**MONTGOMERY COUNTY HISTORIC PRESERVATION COMMISSION**  
**STAFF REPORT**

<b>Address:</b>	10221 Menlo Ave., Silver Spring	<b>Meeting Date:</b>	4/22/2026
<b>Resource:</b>	1870-1916 Capitol View Park Historic District	<b>Report Date:</b>	4/15/2026
<b>Owner:</b>	Kenneth Gear	<b>Public Notice:</b>	4/8/2026
<b>Review:</b>	Historic Area Work Permit	<b>Tax Credit:</b>	n/a
<b>Permit Number:</b>	1079660	<b>Staff:</b>	Dan Bruechert
<b>Proposal:</b>	Construction of New Single-Family House and Grading and Hardscape Alterations

**STAFF RECOMMENDATION**

**Figure 2: Proposed front elevation rendering of the proposed house.**

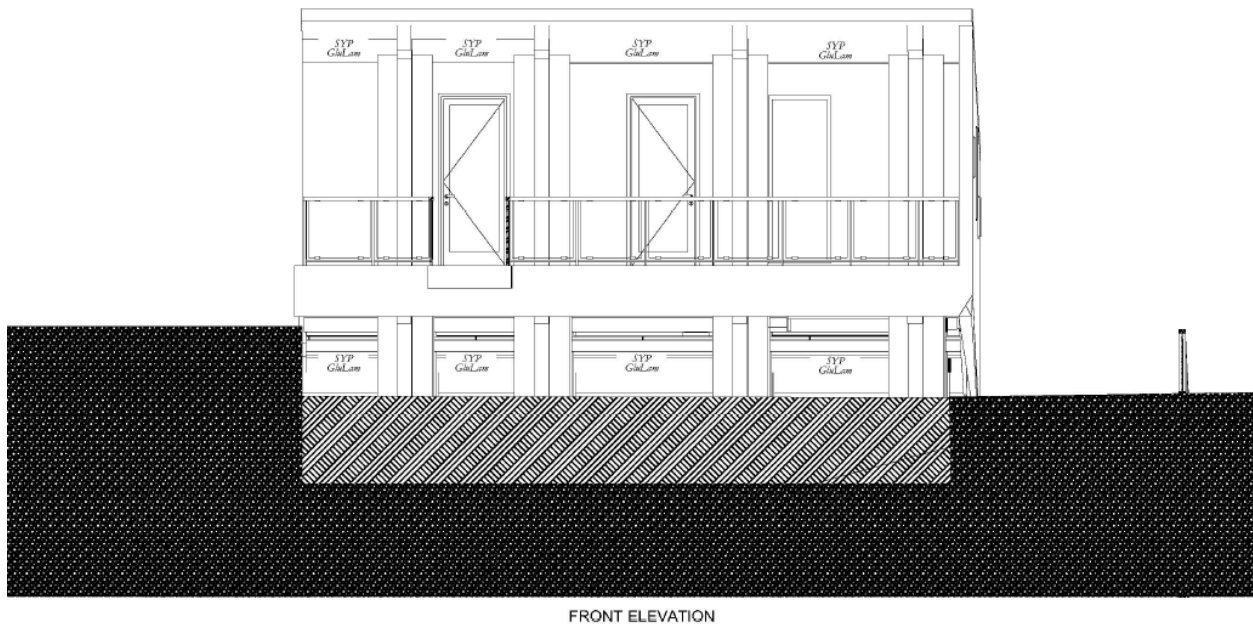
The proposed house design has only been slightly revised and is generally consistent with the proposal supported at the September Preliminary Consultation. The house remains a one-story, contemporary-styled house constructed on wood piers with concrete footers. House dimensions have changed slightly and are now approximately 34' × 39' 10" (thirty-four feet by thirty-nine feet, ten inches deep), which Staff finds are consistent with the 36' × 36' (thirty-six feet square) design reviewed at the Preliminary Consultation. The height at the front of the house is 14' 3 ½" (fourteen feet, three-and-one-half inches) tall. Because of the initial drop in grade at the front of the property, the house will only be 12' 3" (twelve feet, three inches) above the height of Menlo Avenue at grade. The house is set back from the property line by 28' 5" (twenty-eight feet, five inches) with 7' 6" (seven foot, six inch) setbacks on either side. The entrance to the house will be accessed by a wooden bridge that aligns with the left opening on the front elevation. The proposed house is designed to be constructed on three levels so as to follow the slope of the lot. The proposed pent roof matches the slope of the grade, only interrupted by an air vent and the centrally located skylight. The street-facing (west) elevation includes a full-width front porch covered by a cantilevered portion of the roof (see *Figure 2*, below).

The exterior of the house will be sided in smooth stucco, with wood single-lite windows and doors, and

wood decking. A stamped concrete 'patio' is proposed at the front of the property.

**Figure 3: Proposed right (south) elevation option with three windows.**

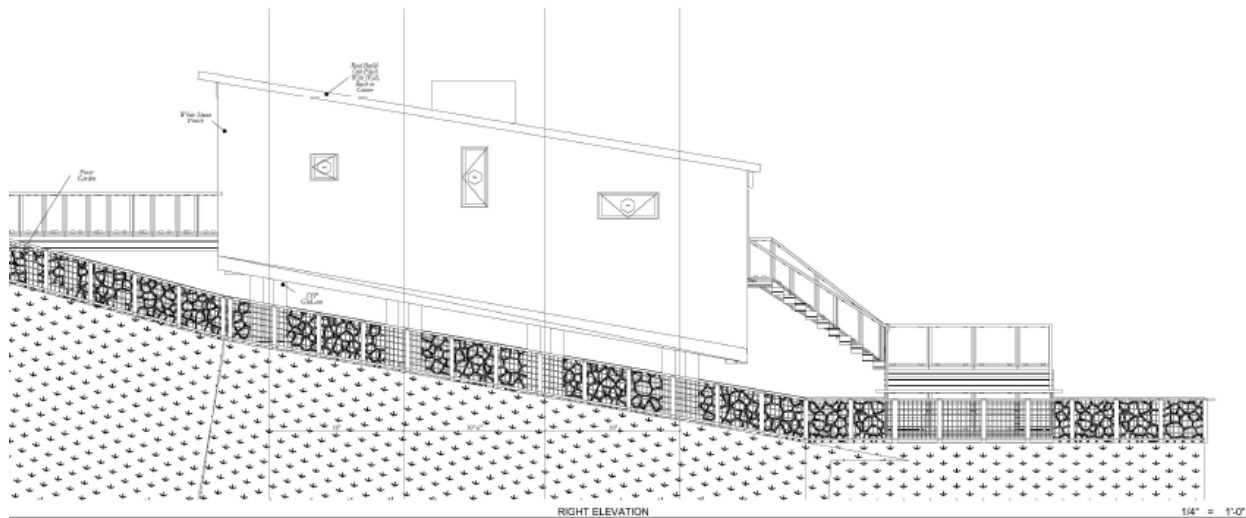
The design presented at the Preliminary Consultation included a blank elevation on the south (right) wall. Based on comments from Staff and the HPC, the applicant revised the design so there are three windows on that elevation, a square casement window, a tall narrow casement window, and a wide narrow awning window (see *Fig. 3*, below). The rear (east) and left (north) elevations face out of the historic district and are not at all visible from the public right-of-way (*Figs. 4* and *5*). Both of these elevations are largely glazed, with evenly spaced windows at the rear and three pairs of glass doors along the right elevation. An exterior wood walkway stair runs along the northern elevation that provides access to the rear yard.

Staff finds the diminutive size of the house will not overwhelm the character of the site or the surrounding district, and its one-story height, coupled with the design's pent roof, will make this the shortest house on the block. Staff additionally finds that the house's placement on the lot, setback 28' 5" (twenty-eight feet, five inches) from the right-of-way is generally consistent with the other houses along Menlo Ave. which range from a minimum of 15' (fifteen feet) – a distance closer to the street than what is allowed under current zoning - to a maximum of 84' (eighty-four feet). Staff additionally finds that raising the house on piers and creating a terraced landscape (discussed below) allows for an open green space surrounding the house which reinforces the garden setting of the historic district.

**Figure 4: Proposed left (north) elevation.**

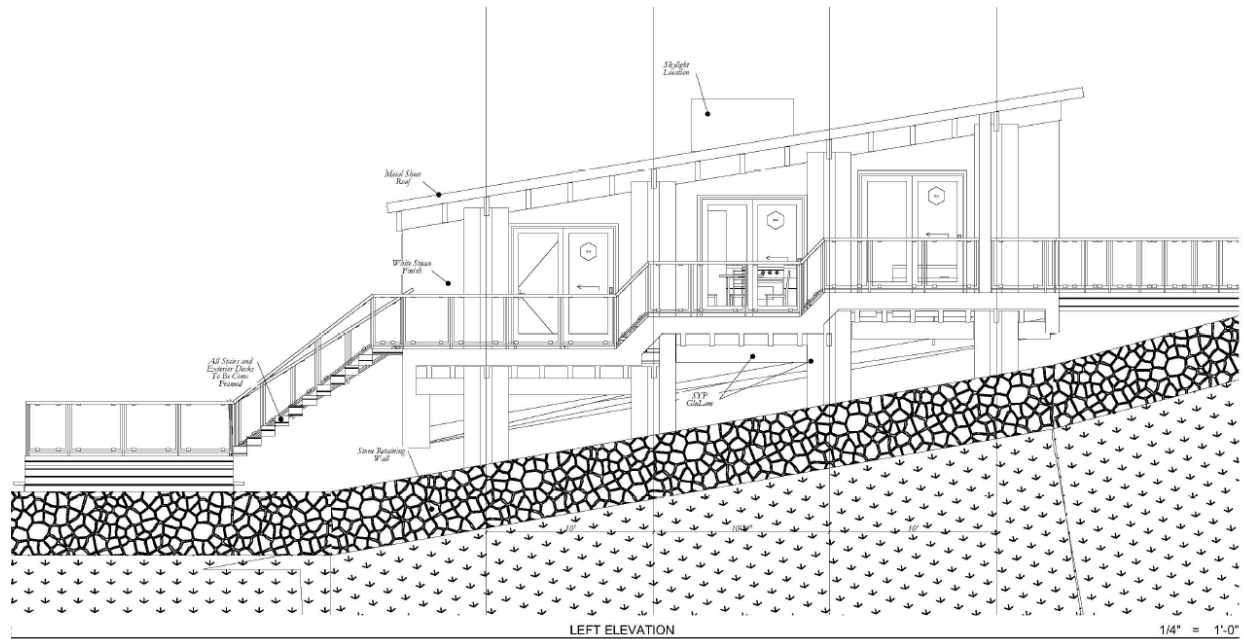
Staff finds the proposed design, though distinctly contemporary, will likely not detract from the character of the surrounding district. The roof form, window size, and scale are all intended to stand apart from the historic buildings and historic building styles found throughout the historic district. By utilizing the pent roof that aligns with the lot slope, the overall mass of the house is kept low to reduce the overall visual impact on the district and avoids overwhelming the resource, a common challenge with new construction in this historic district. Evaluating contemporary architecture in historic districts requires finding factors such as siting, massing, proportions, and materials - and not necessarily its stylistic elements – that can help make a design appropriate under *Standard #9*, which encourages compatibility while differentiating between new and historic elements.

**Figure 5: Proposed rear elevation.**

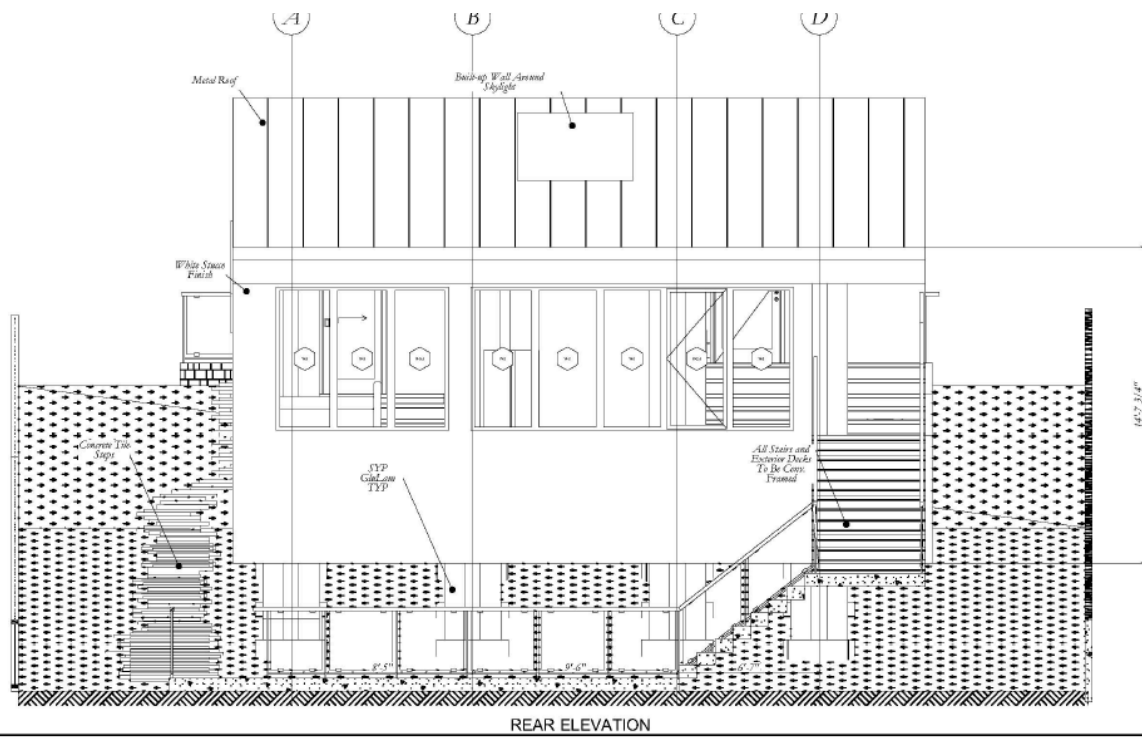
The applicant presented several options for siding the proposed construction at the Preliminary Consultation, including fiber cement and stucco. In finalizing the design details, the applicant opted for stucco, a material supported by Staff and the commissioners present at the Preliminary Consultation. All of the windows are wood-framed, single-light fixed or casement/awning windows in punched openings. A specification beyond the material and configuration was not included for the windows and doors. Staff finds that because this is new construction and because all of the windows are single-lites, Staff recommends adding a condition to the approval of this HAWP requiring the applicant to submit detailed material specifications (i.e., manufacture and series) for the windows and doors. Final approval authority can be delegated to Staff to verify the windows are wood and the dimensions are consistent with those specified in the provided window schedule. With the recommended condition, Staff finds the windows are doors are appropriate under 24A-8(b)(2) and (d) and *Standard #9*.

Staff previously found that because the low-sloping pent roof will not be at all visible, a metal or membrane roof would be acceptable. Commissioners generally concurred with this finding at the Preliminary Consultation. The applicant has selected a standing seam metal roof. As with the windows, a material specification was not provided. However, Staff finds the detail with the largest impact on contemporary standing seam metal roofs is the treatment of the ridges and hips, which rely on capping pieces that stand proud of the roof surface. Because the proposed roof is a pent roof, it will not include these caps. Therefore, Staff recommends that the HPC add a condition to the approval of the roof requiring the applicant to provide detailed roofing specifications. With the recommended condition, Staff finds the roof is compatible with 24A-8(b)(2) and (d) and *Standard #9*.
